Planning Application - 2021/5939/P - Utopia Village 7 Chalcot Road London NW1 8LH

UTOPIA OFFICE – NEW PLANT EQUIPMENT NOISE ASSESSMENT

INITIAL REVIEW AND COMMENTS – REV A

7TH AUGUST 2020

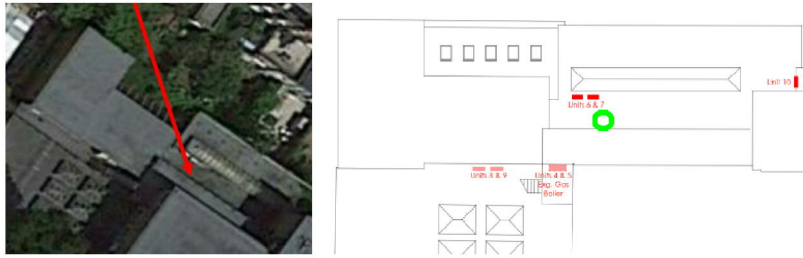
However, the survey location could have been chosen to be closer to the sensitive receiver and it is likely that the existing noise level at the lower rear windows of houses on Gloucester Avenue will be lower than that measured as they are more shielded from surrounding noise sources. It might be considered to do a repeat of the survey at a location that is more representative.

Another area that might be reviewed are the assumptions used in the plant noise assessment calculation. It could be argued that, based on less favourable assumptions, the calculated level at the assessment location will be above the target value. It should be considered to challenge these assumptions and the resultant conclusion about noise impact.

In terms of additional information, it is suggested that further evidence is provided that the installed enclosure will provide the sound reduction performance that is used in the calculation. It is also suggested that the hours of plant operation are clearly conditioned and restricted to match the basis of the assessment. Also, to confirm that the installation operates as predicted by the calculations, it is recommended that appropriate commissioning measurements are made a condition to be discharged prior to occupation/operation of the building.

5 Allowance for Plant Tonality

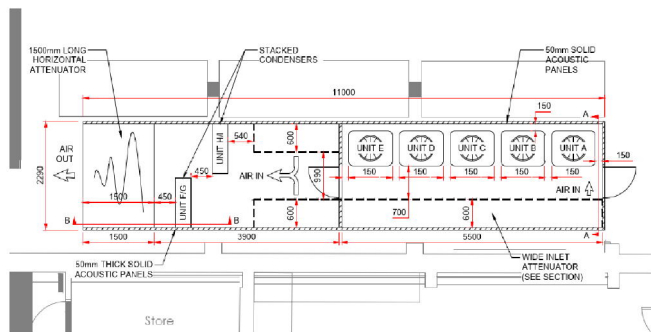
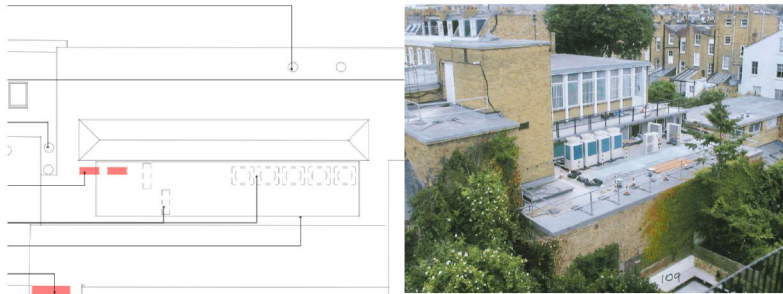
The assessment procedure follows that standard approach (as described in BS 4142). This standard recommends that a correction is made to noise levels to account for tonality. i.e. a penalty is applied to account for the fact that tonal noise has more potential to disturb than broadband noise. The assessment does not apply any correction for tonality, arguing (clause 7.3) that is “no evidence of any tonal content” for the proposed plant equipment. This is reasonable for the plant in isolation. However, the acoustic enclosure does not have a constant performance across the frequency spectrum. In effect, it applies a low-pass filter to the noise from the equipment and the resulting noise at the receiver position will be dominated by low-frequency sound. The figures given in Appendix 3 of the Plant Noise Assessment Report (Noico 72003022/1) suggest that the noise level at 63Hz will be 16dB higher than that at 125Hz. We would suggest that this runs contrary to the statement that there is “no evidence of any tonal content” and should be reviewed.

Possible action: Request that the correction for tonality is applied to the noise after the inclusion of the effect of the enclosure.
